FAX TRANSMITTAL

Subject Horton Drivemaster 989012/999012

NEW MOUNTING
LOCATION
FOR HORTON 999012

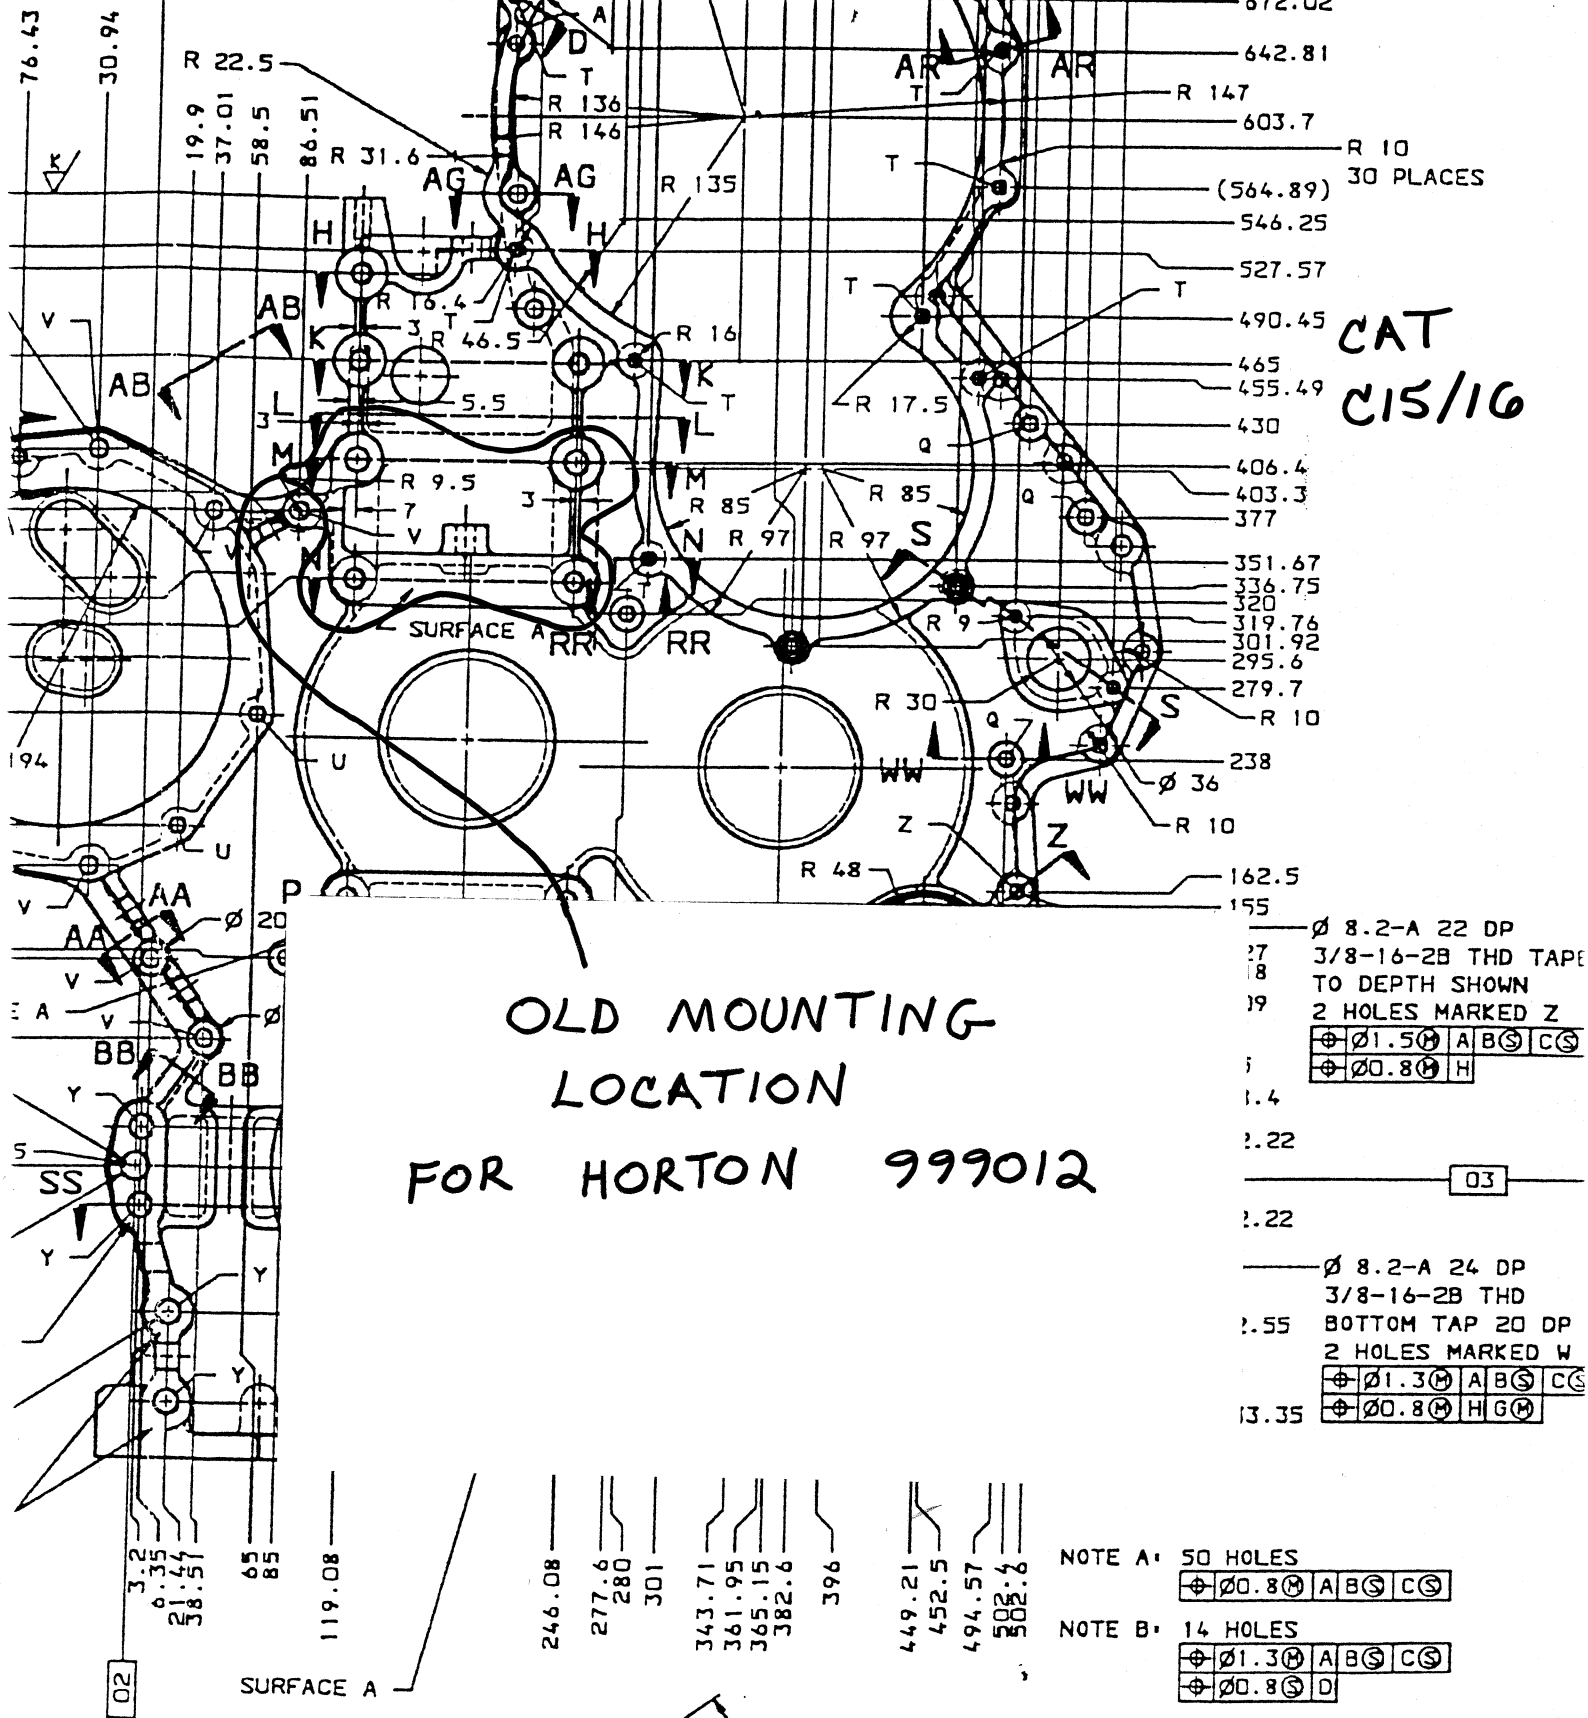
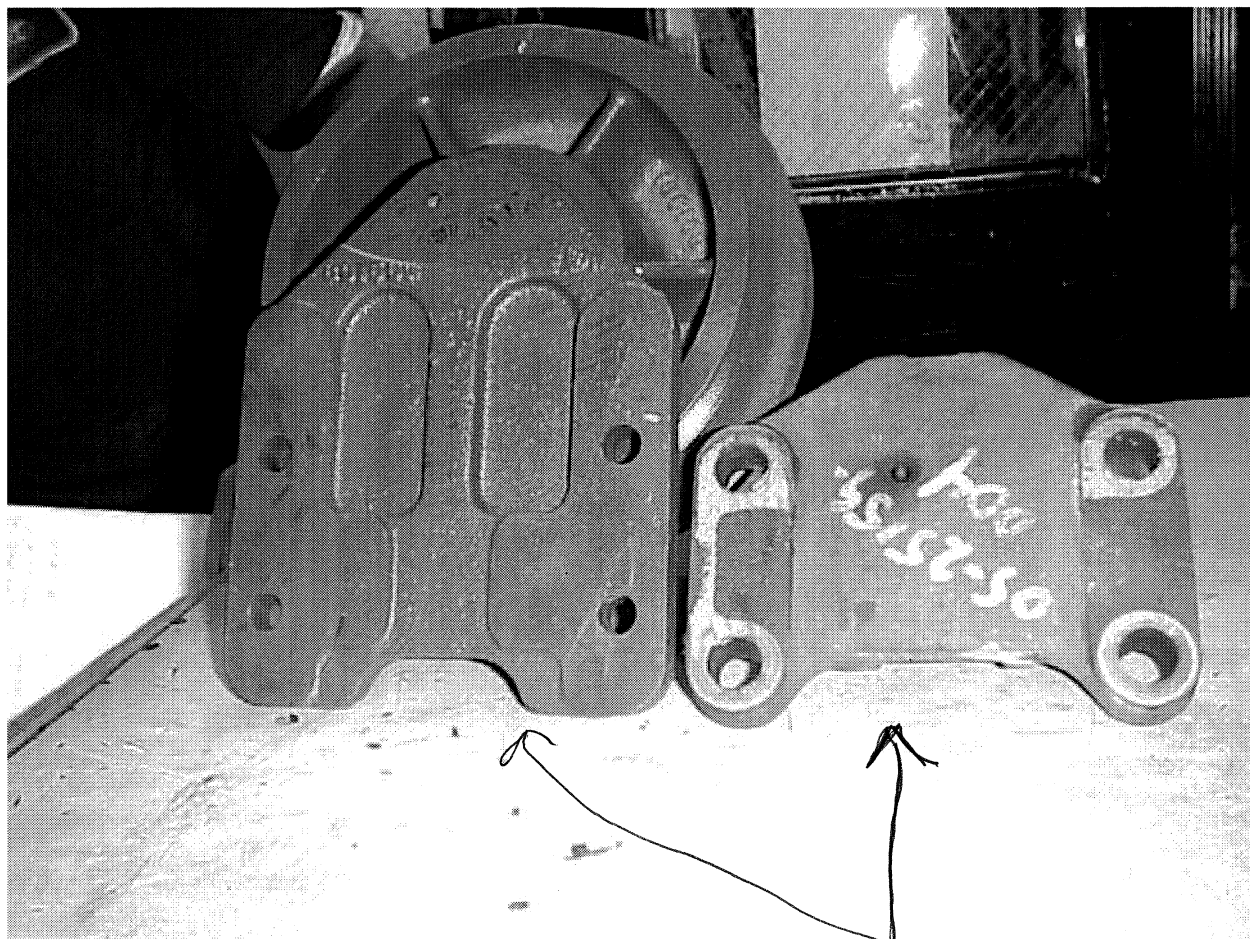
In August of last year, per Peterbilt's request, Horton changed the journal bracket on the 999012. This was done so that during engine dress Horton and Borg-Warner fan drives would share the same engine mounting stud locations. The fan center did not change when the new journal bracket was implemented only the mounting location.

What mechanics are encountering during service is that the replacement fan drive has the new bracket, which uses different mounting holes on the engine.

DriveMaster 999012's built before Serial # 2790699 use the old bracket; therefore, replacement with current production 999012's requires relocating the engine-mounting studs. (See accompanying drawings for clarification)

AUG 00 changed brkt. FROM TO.

NOW 14998

WAS 14766
